Planning Condition Discharge

HGY/2025/0818 Tottenham Hale Station

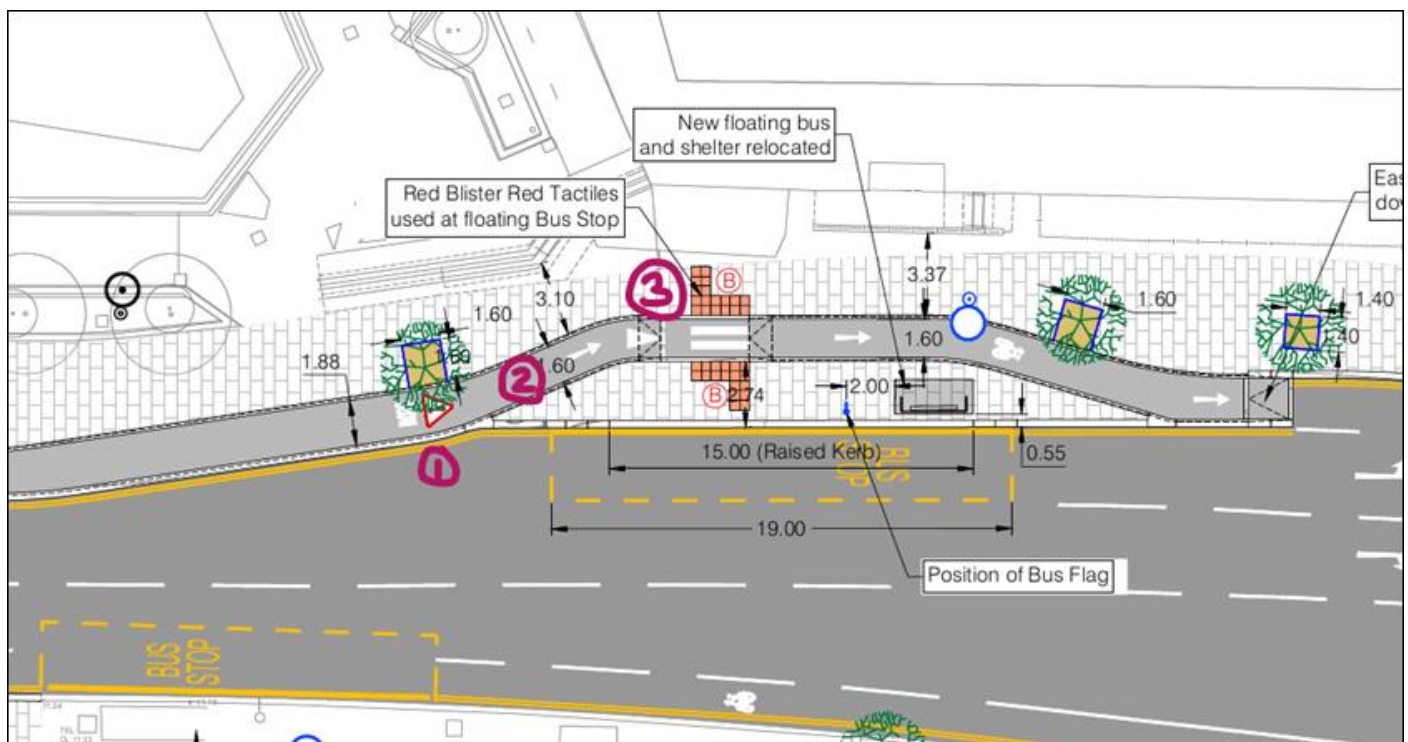
The proposed ramping of the eastbound cycle lane on Ferry Lane needs to show the gradient. Of particular concern is the potential for cyclists to gain speed on the downwards slope when exiting from the floating bus stop area to carriageway level.

It is unclear from the submitted plans if there are any speed restriction measures to be employed on the downward slope. These should be clearly annotated on relevant plans. It is noted that on the approach to the floating bus stop area there is a slow warning marking.

The gradient of the east bound cycle track from the crest to the bridge to the discharge point into the carriageway generally ranges between 3.0 - 3.5% (1 in 33 to 1-28, this is within the acceptable gradient limits.

To reduce the speeds of cyclists, horizontal and vertical deflections have been added alongside the Warning Road Marking.

- 1) **Warning / Slow Road Marking - Warning**
- 2) **Horizontal Deflection – Track turns around Island**
- 3) **Vertical Deflection – 50mm Raised Table Introduced at crossing to the island (at CH. 255 within the attached Drawing)**

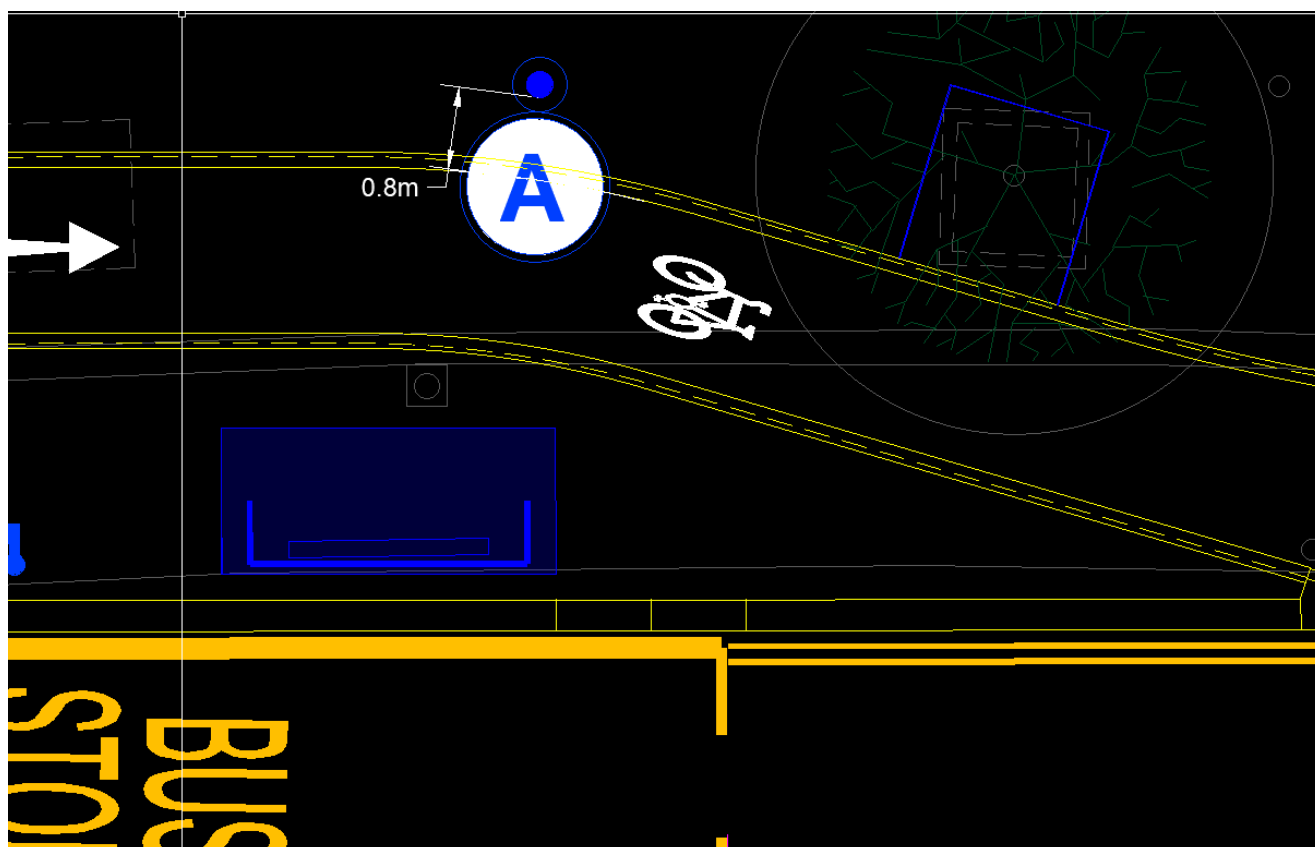
Clarity is sought that the proposed new lighting column opposite the re-located bus shelter at the floating bus stop on Ferry Lane does not encroach into the cycle lane.

As stated in the lighting design drawings, all columns will have a minimum set back from any kerb face of 0.8m. There will not be any lighting columns installed in the cycle lane, please see details below.

Proposed CCTV coverage

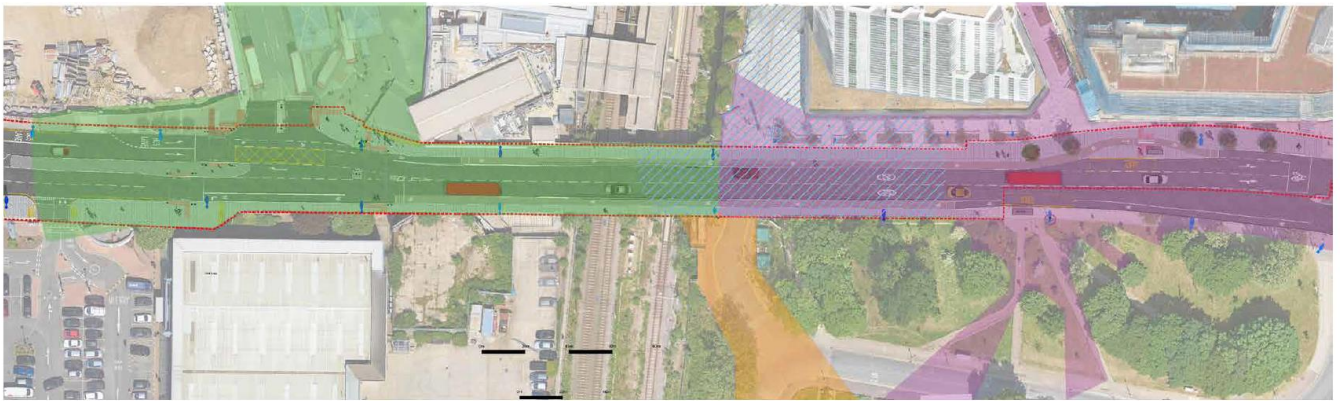
Clarity is sought that the CCTV proposed for the westbound bus stop area on Ferry Lane, opposite the floating bus stop area in the eastbound direction, will also cover the eastbound floating bus stop area.

The diagram below shows the coverage of the 3 CCTV cameras to be installed. The Eastbound floating bus stop area will be covered by CCTV
